**Engine Control**

YEAR(S)	MODEL(S)	ADDITIONAL INFORMATION
2012 – 2014	Tacoma

Some 2012 – 2014 model year Tacoma vehicles equipped with 1GR-FE engines may exhibit a MIL "ON" condition for the following Diagnostic Trouble Codes (DTCs):

Figure 1. Location of Authorized Modifications Label on 2012 - 2014 Tacoma

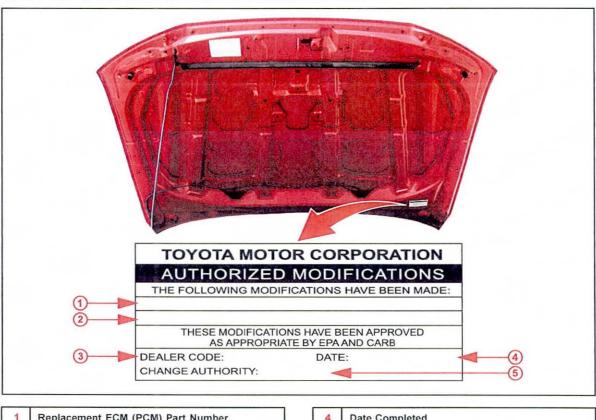
- YES Continue to step 2.
- NO This bulletin does NOT apply. Continue diagnosis using the applicable Repair Manual.
- 2. Check for the Authorized Modifications Label affixed to the vehicle in the location shown in Figure 1. Confirm if the ECM (PCM) calibration has been updated. If the calibration ID listed is NOT the latest ECM (PCM) calibration — go to step 3. If the calibration ID is the latest, go

- 4. Install the Authorized Modifications Label.
  - A. Using a permanent marker, enter the following information on the label:
    - ECM part number [Refer to the Parts Information section for the NEW PART NUMBER]
    - Calibration ID(s) [Refer to the Calibration Information section for the NEW CALIBRATION ID]
    - Dealer Code
    - Repair Date
    - Change Authority [This bulletin number]
  - B. Affix the Authorized Modifications Label to the vehicle at the location shown in Figure 1. The Authorized Modifications Label is available through the MDC, P/N 00451-00001-LBL.
- Test drive to confirm the repair.
